STAFF REPORT AND RECOMMENDATION TO THE DESIGN COMMISSION

CASE FILE: LU 13-211645 DZM
PC # 13-154618
11th & Jefferson Apartments
REVIEW BY: Design Commission
WHEN: January 9, 2014 @ 1:30pm
WHERE: 1900 SW Fourth Ave., Room 2500A
Portland, OR 97201

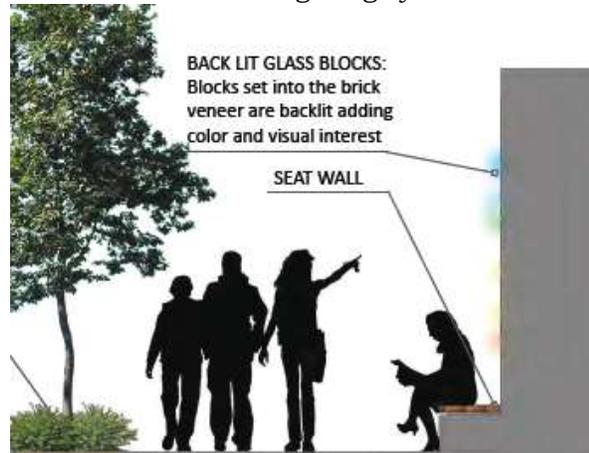
C11. Integrate Roofs and Use Rooftops. Integrate roof function, shape, surface materials, and colors with the building's overall design concept. Size and place rooftop mechanical equipment, penthouses, other components, and related screening elements to enhance views of the Central City's skyline, as well as views from other buildings or vantage points. Develop rooftop terraces, gardens, and associated landscaped areas to be effective stormwater management tools.

Findings: As noted above, the proposed mechanical equipment is concentrated at the north side of the central bar and is sufficiently hidden from view from the street and from higher points in the area by rooftop walls and screens on the proposed building. Rooftop decks are proposed for private use at the northeast and southwest corners and for common use at the southeast corner where a larger patio is proposed connected to an enclosed common room containing a full kitchen. Decorative planters are proposed at the rooftop deck; however stormwater will only be managed through the 2nd floor mezzanine courtyard planters. *This guideline is met.*

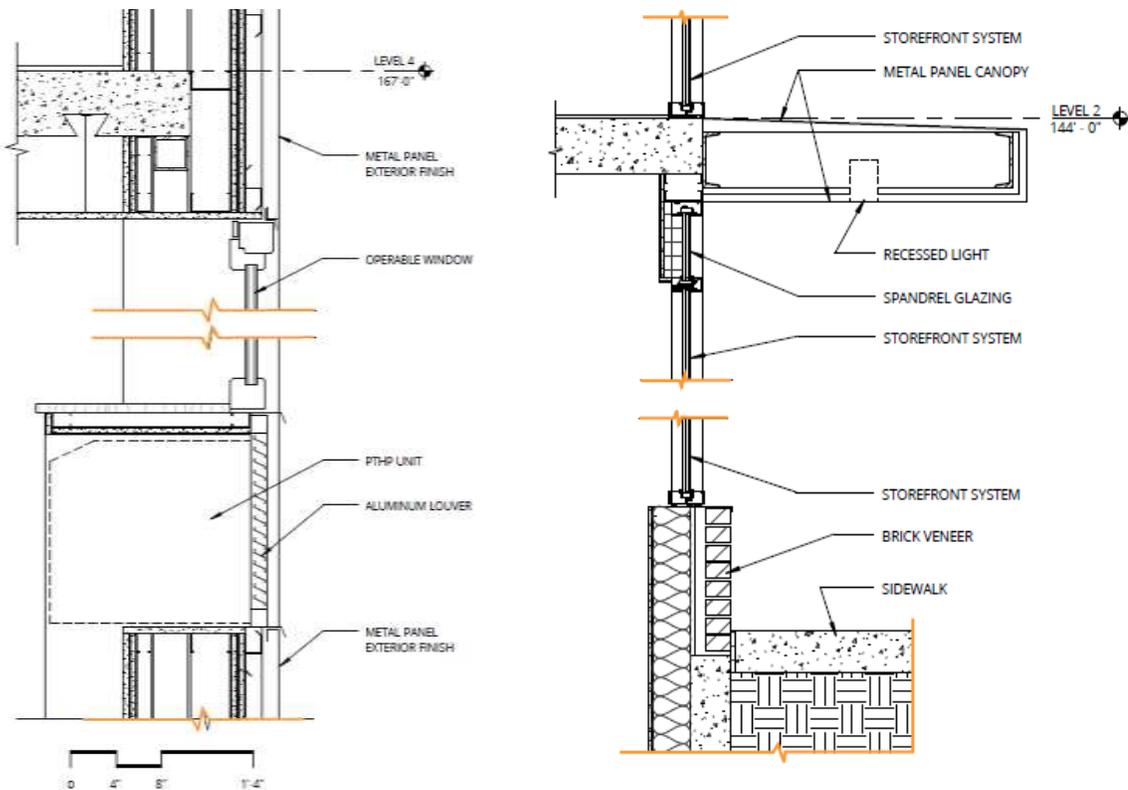
Findings: The proposal includes barrier-free access at the SW 11th Avenue residential entrance and at the rear courtyard via a ramp accessing SW 12th Avenue. The sidewalk level of the building is currently designed for use as either a single retail space (C.25) or four separate retail spaces (C.26), one of which is two levels. Therefore, the proposed design is relatively unobstructed and could be reconfigured to create smaller or larger spaces. Although not shown in the plan drawing of the Ground Level Plan (C.37), elevation and perspective drawings show that, in the multiple retail space option, the two center retail spaces may feature

accessible entries connecting directly to SW Jefferson Street. It is not as clear, however, how barrier-free access will be provided to the southwest retail space. In the multiple retail space option, it appears that the physically impaired will have to travel through a back hallway with several turns in order to gain access to this space. Staff wonders if a more direct route can be provided between this retail space and the public realm which will work for either option in order to maximize the flexibility and the accessibility of the sidewalk-level spaces.

Provided the applicant can demonstrate that relatively easy barrier-free access is provided to the southwest retail space, these guidelines will be met.
